Tianli Petrochemical Company
310 KTPA HDPE Plant

DRAWING TITLE: Fluidized Bed Dryer (16-DR-221) Outline Drawing for Fluid Bed Dryer Package Unit (16-PK-221)

DRAWING TITLE: Fluidized Bed Dryer (16-DR-221) Lifting Drawing of Lower part for Fluid Bed Dryer Package Unit (16-PK-221)

DRAWING TITLE: Fluidized Bed Dryer (16-DR-221) Lifting Drawing of Upper Part for Fluid Bed Dryer Package Unit (16-PK-221)

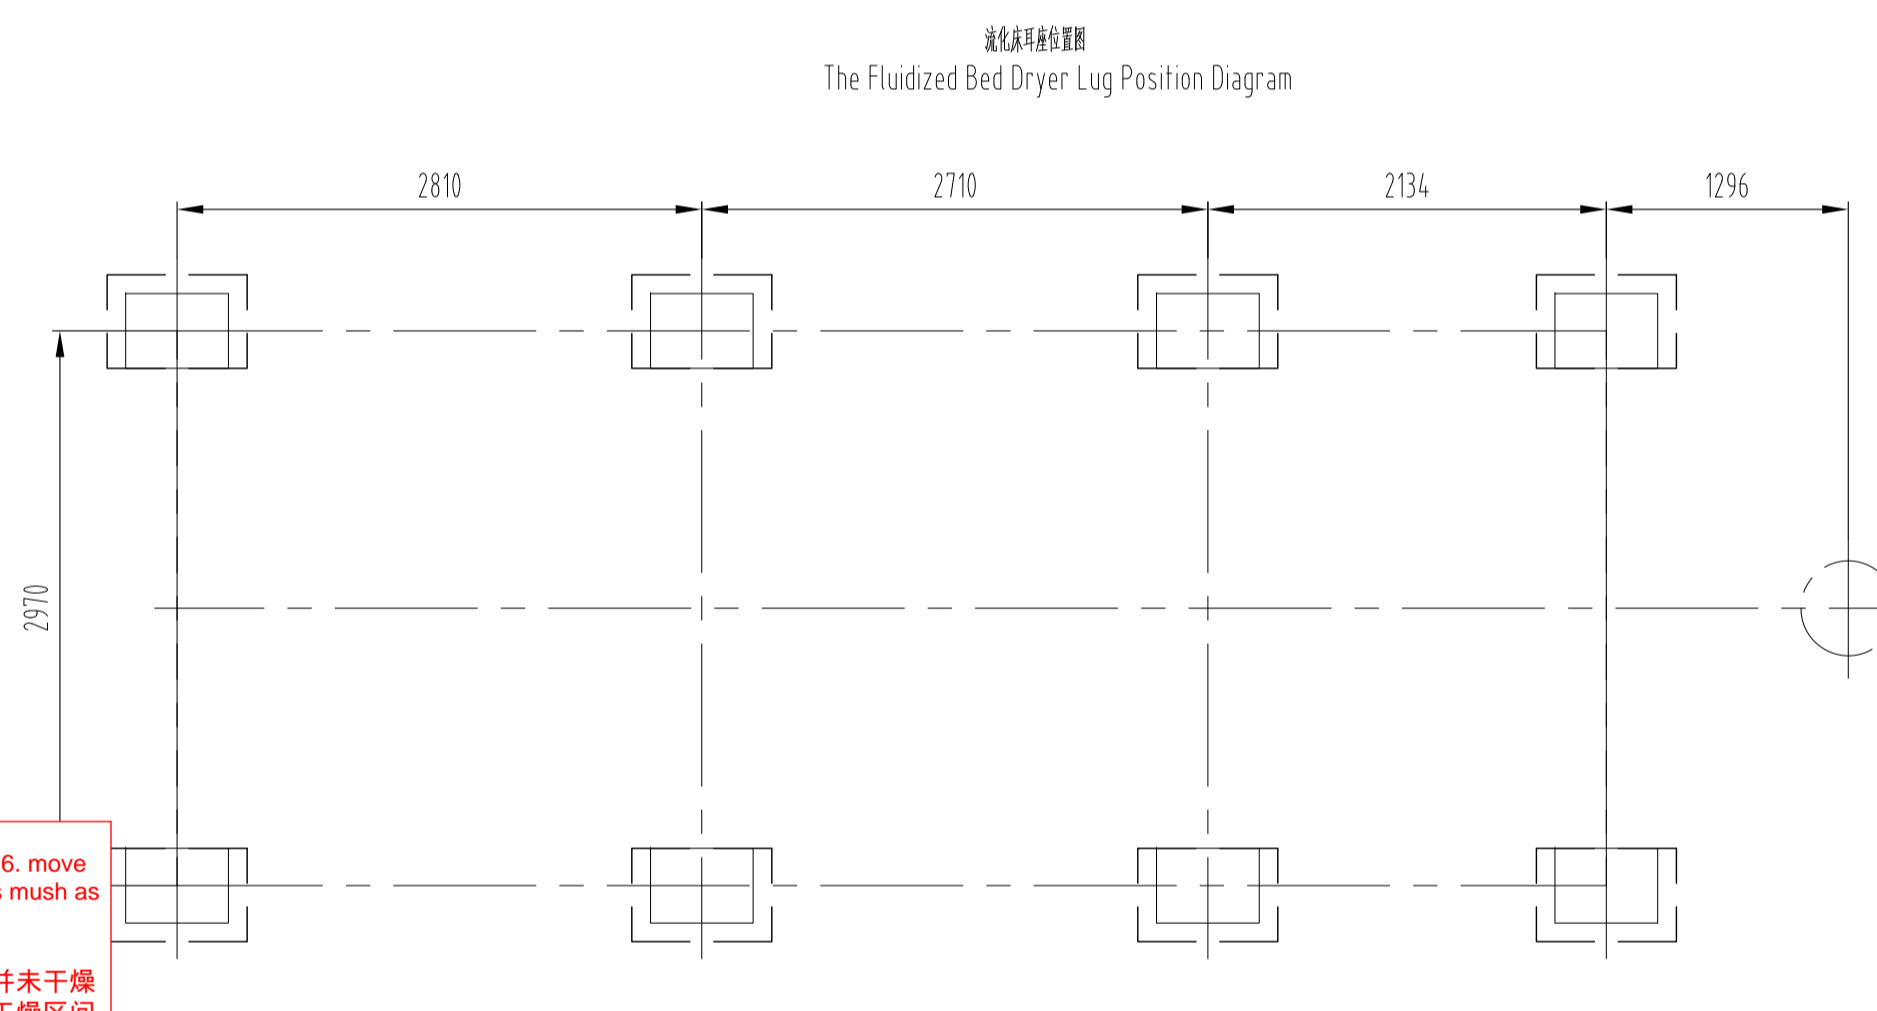
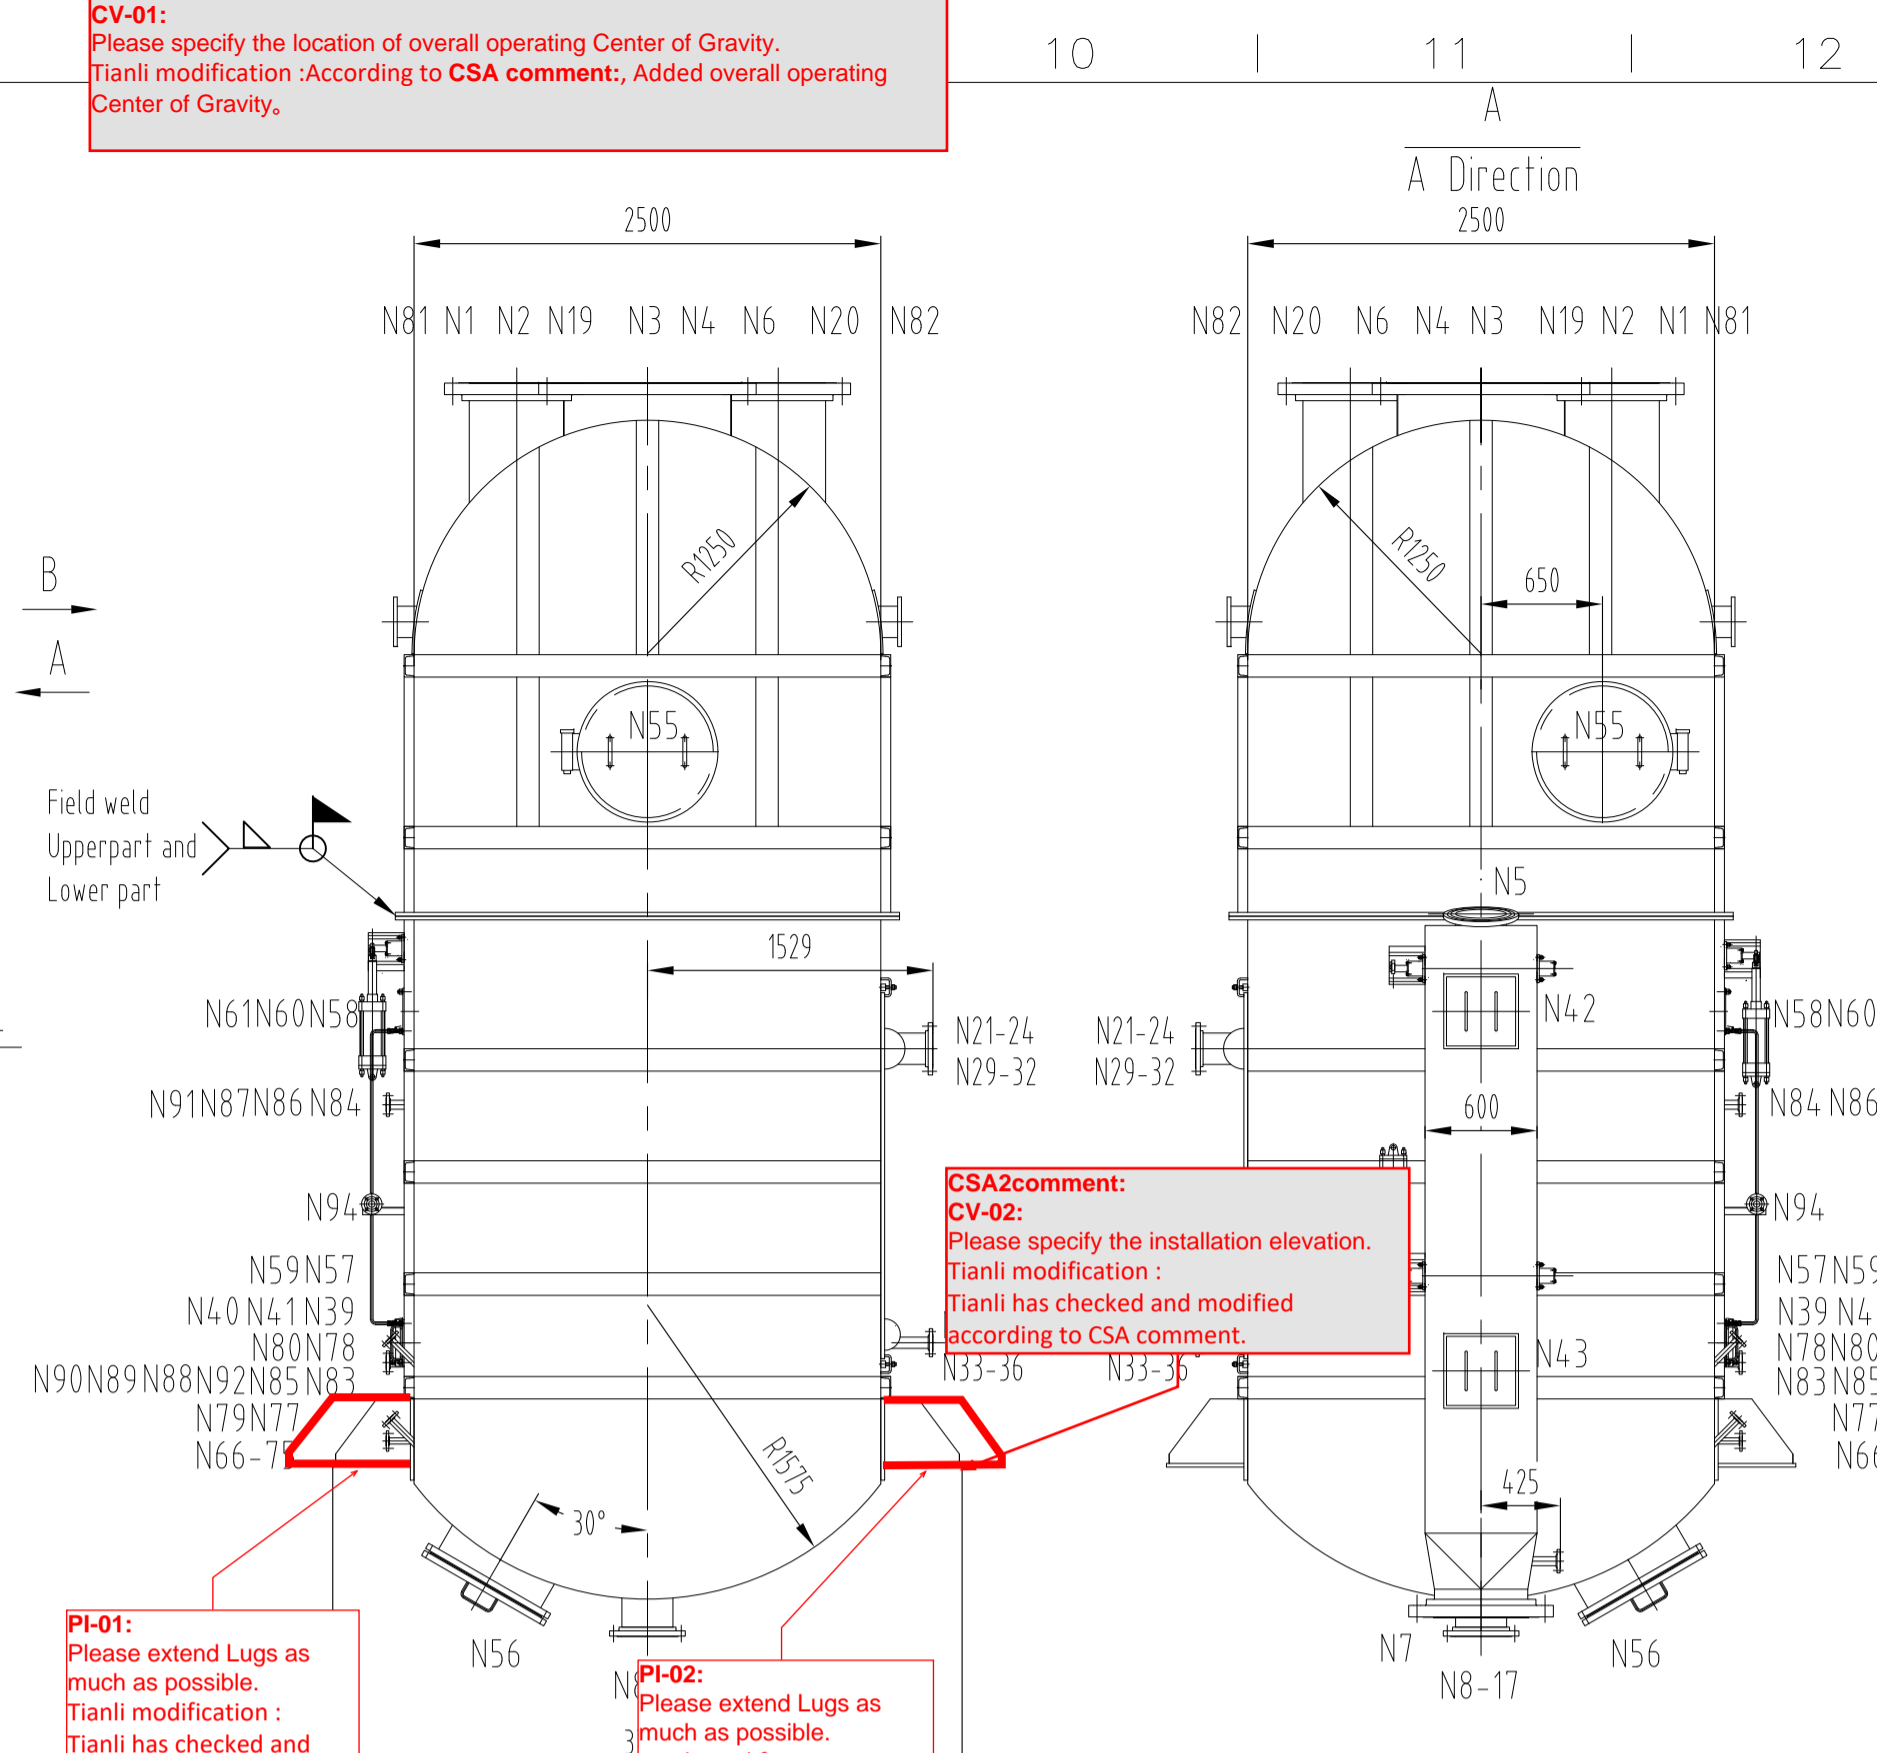
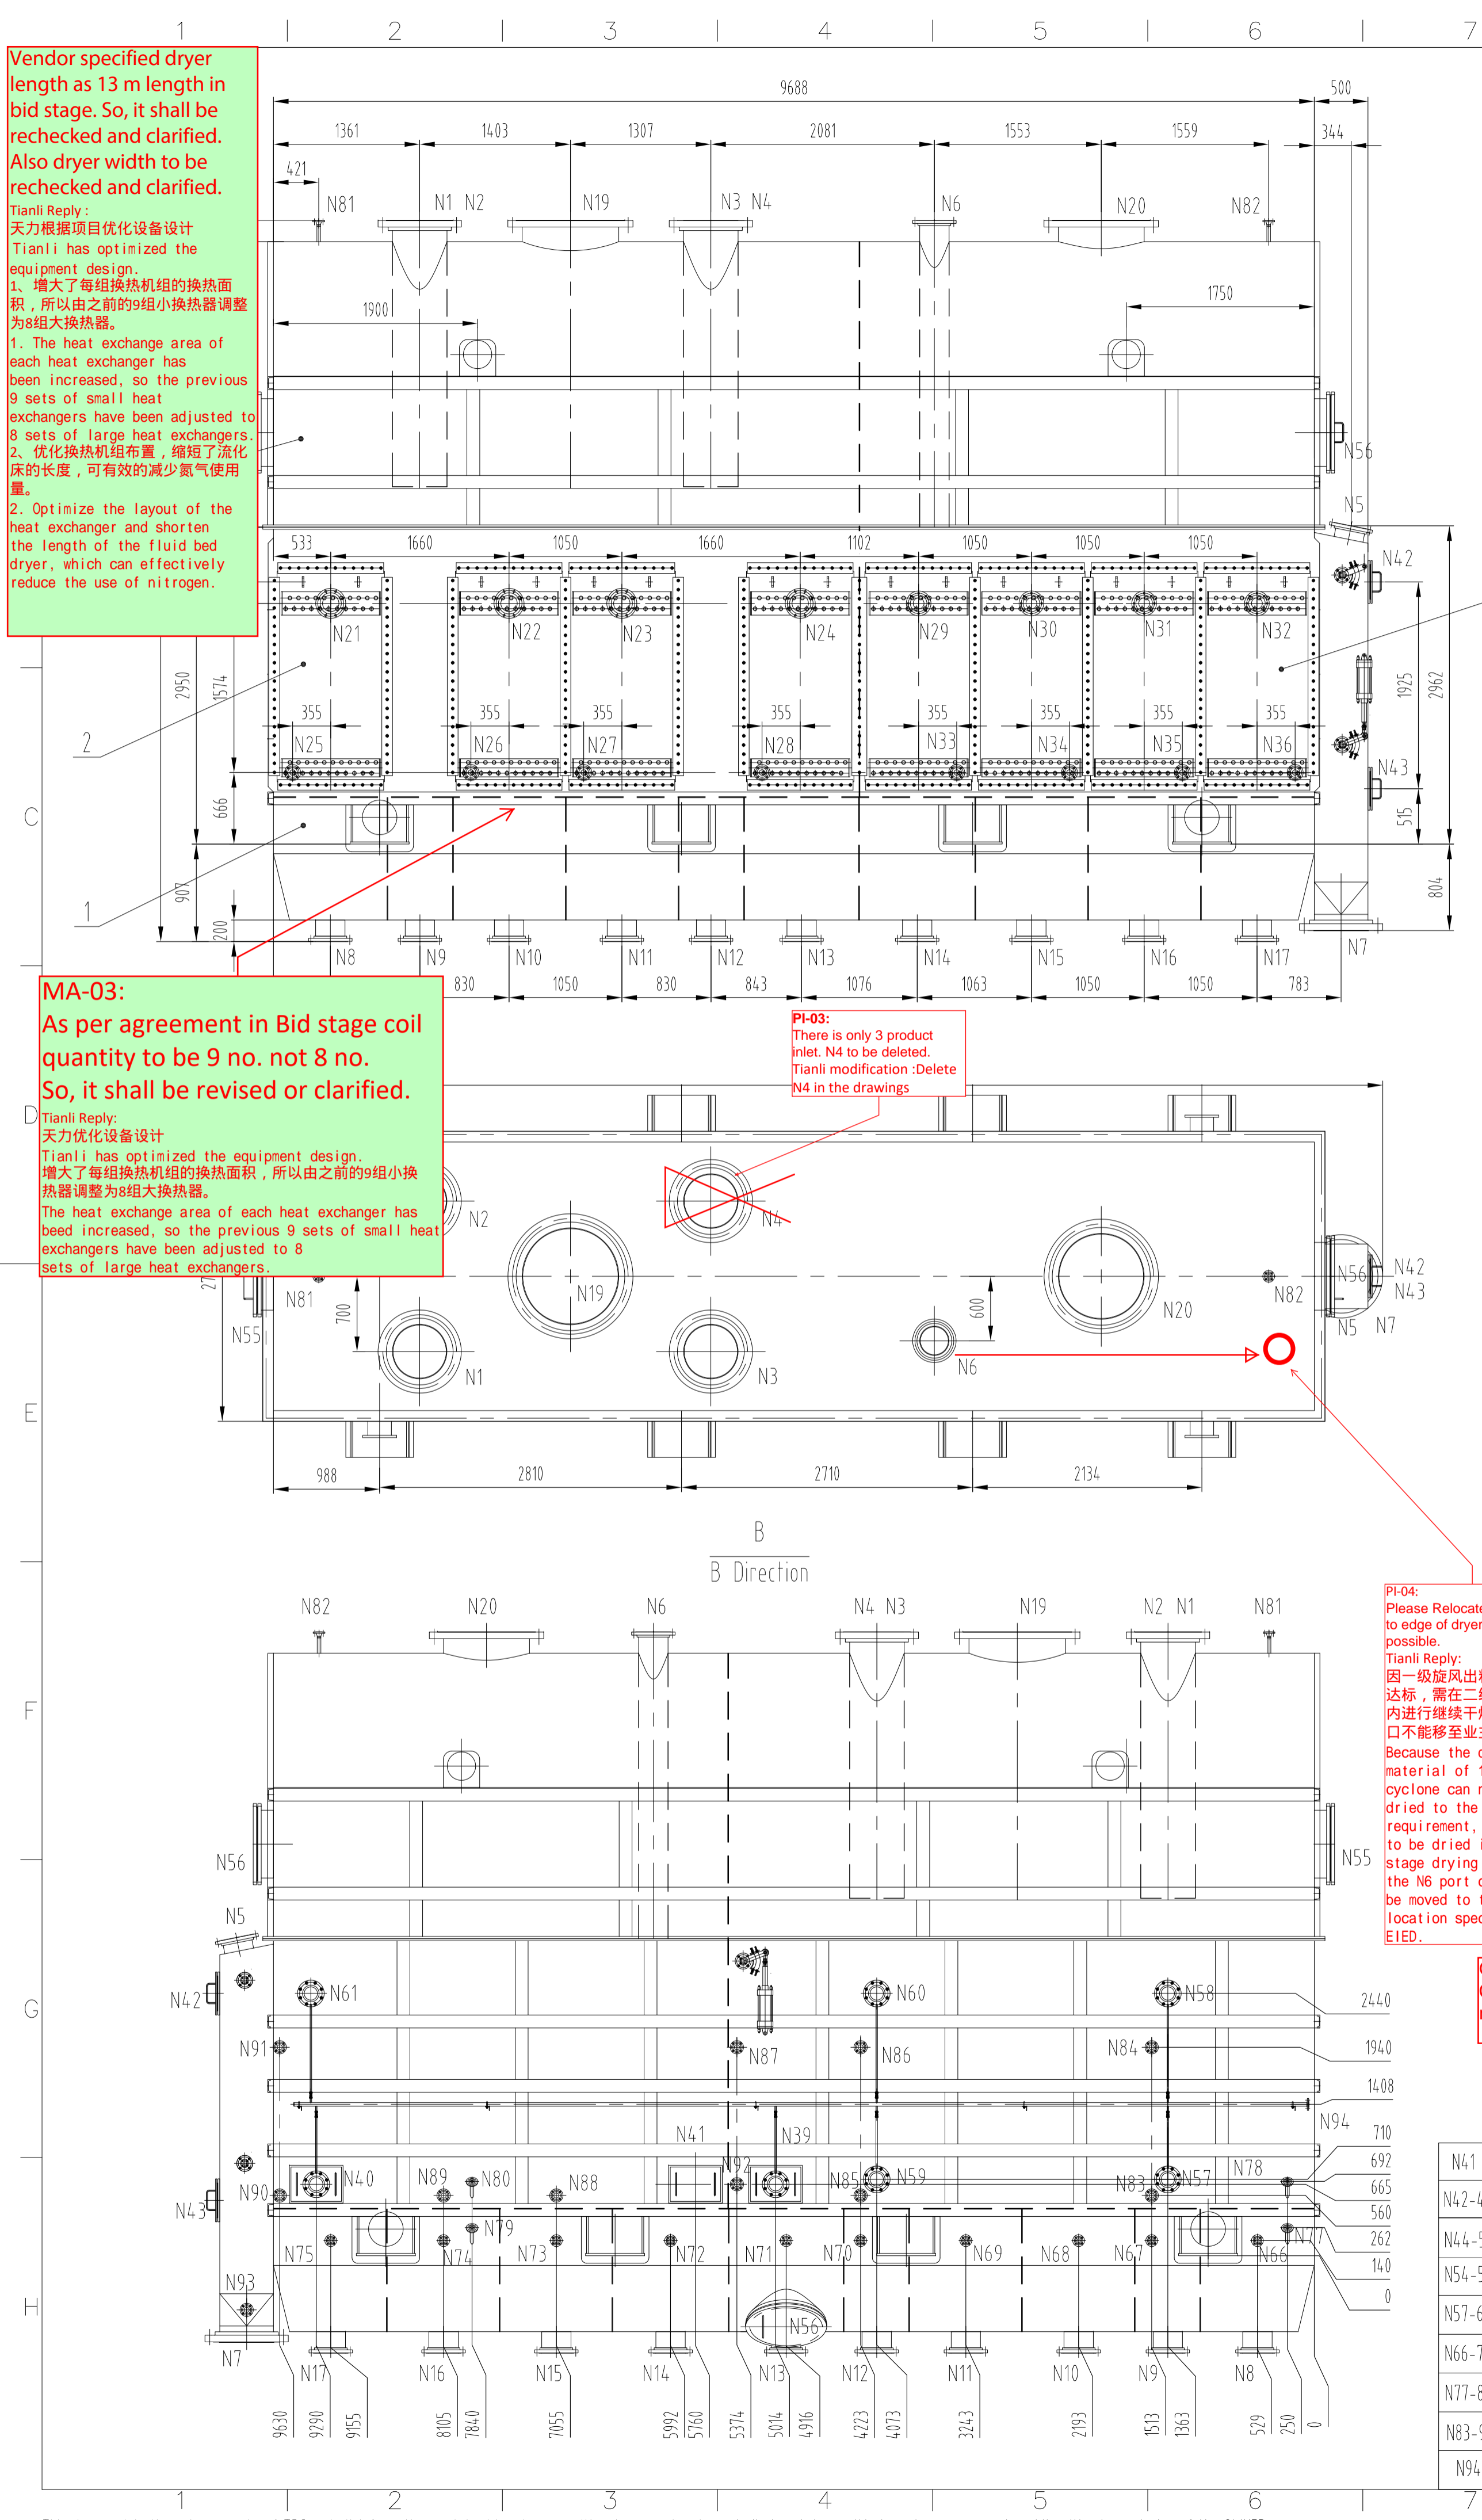
Vendor specified dryer length as 13 m length in bid stage. So, it shall be rechecked and clarified. Also dryer width to be rechecked and clarified.

CSA comment:
CV-01:
Please specify the location of overall operating Center of Gravity.
Tianli modification :According to CSA comment; Added overall operating Center of Gravity.

MA-03:
As per agreement in Bid stage coil quantity to be 9 no. not 8 no. So, it shall be revised or clarified.

PI-03:
There is only 3 product inlet. N44 to be deleted. Tianli modification :Delete N44 in the drawings

PI-01:
Please extend Lugs as much as possible. Tianli modification : Tianli has checked and modified according to CSA comment.

PI-02:
Please extend Lugs as much as possible. Tianli modification : Tianli has checked and modified according to CSA comment.

CSA2comment:
CV-02:
Please specify the installation elevation. Tianli modification : Tianli has checked and modified according to CSA comment.

MA-02:
As per MA DSH: Operation temperature: 90
Tianli Reply:
天力已在设备外形图中修改。Tianli has modified on the Equipment Outline Drawing.

MA-03:
As per MA DSH: Operation temperature: 110
Tianli Reply:
天力已在设备外形图中修改。Tianli has modified on the Equipment Outline Drawing.

CSA2comment:
CV-03:
Please specify test weight. Also please specify the type of presented "Maximum weight".
Tianli Reply:
天力已在设备外形图中补充说明此问题。Tianli has clarified this issue on the Equipment Outline Drawing.

CSA2comment:
CV-04:
With respect to the note that the supported structure is concrete one, so related lugs are welded to insert plates. Please specify the location and dimensions of required insert plates. Also please refer to "CV-05".
Tianli Reply:
天力已在设备外形图中补充说明此问题。Tianli has clarified this issue on the Equipment Outline Drawing.

CSA2comment:
CV-05:
According to the construction problems such as leveling in concrete structures, utilizing anchor bolts and grout is proposed for supporting this equipment (instead of welding to the insert plates).
Tianli modification : Tianli has checked and modified according to CSA2 comment.

MA-04:
MECHANICAL SCATTER FOR EACH LINE OF POWDER ENTRANCE WHICH ARE COMING FROM CENTRIFUGES TO BE CONSIDERED AS PER AGREEMENT.

MA-06:
As per design basis: 0.6 barg
Tianli Reply:
天力已在设备外形图中修改。Tianli has modified on the Equipment Outline Drawing.

Tianli Reply:
天力根据项目优化设备设计。Tianli has optimized the equipment design.
1. 增大了每组换热机组的换热面积，所以由之前的9组小换热器调整为8组大换热器。
1. The heat exchange area of each heat exchanger has been increased, so the previous 9 sets of small heat exchangers have been adjusted to 8 sets of large heat exchangers.
2. 优化换热器布置，缩短了流化床干燥器的长度，可有效的减少氮气使用量。
2. Optimize the layout of the heat exchanger and shorten the length of the fluid bed dryer, which can effectively reduce the use of nitrogen.

Tianli Reply:
天力优化设备设计。Tianli has optimized the equipment design.
增大了每组换热机组的换热面积，所以由之前的9组小换热器调整为8组大换热器。
The heat exchange area of each heat exchanger has been increased, so the previous 9 sets of small heat exchangers have been adjusted to 8 sets of large heat exchangers.
